Access Compliance Report

Public Rights-of-Way (Curb Ramps)

Intersection ID: 6141	Main Street: CATHEY_RD	Cross Street: ENWOOD_DR	Location:	N
ADA ID: E6335C11BBA5	Ramp Type: Perp	Initial Pass/Fail: Fail	Overall Compliance: No	Severity Score: 33.75

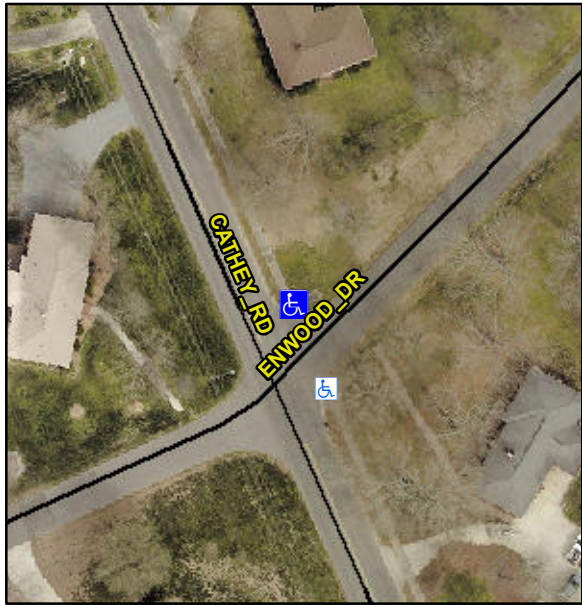
Codes/Mitigation Info/Possible Solution			Field Measurements/Component Compliance					
	Possible Solutions:		Remove & Replace Entire Ramp.					
	Surveyor Notes:		N/A					
	PROW/ADA:		Not Found, R304.5.1, R304.2.2, R304.5.3					
	Street 1 Name		ENWOOD DR					
	Stop Condition-Street 2		None					
	Street 2 Name		N/A					
	Stop Condition-Street 1		N/A					
	Total Cost:		\$ 1850.00					
			Compliance	Description	Data	Compliance	Description	Data
			N/A	Ramp Length (in)	48.5	No	Ramp Slope (%)	8.6
			No	Ramp Width (in)	46.5	No	Ramp XSlope (%)	5.6
			N/A	Flare Type LT	N/A	N/A	Flare Type RT	N/A
			N/A	Flare Slope LT (%)	N/A	N/A	Flare Slope RT (%)	N/A
			N/A	Flare Traversable LT?	N/A	N/A	Flare Traversable RT?	N/A
			N/A	Landing Length (in)	N/A	N/A	DWS Provided?	N/A
			N/A	Landing Width (in)	N/A	N/A	DWS Contrast?	N/A
			N/A	Landing Slope (%)	N/A	N/A	DWS Length (in)	N/A
			N/A	Landing X Slope (%)	N/A	N/A	DWS Full Width?	N/A
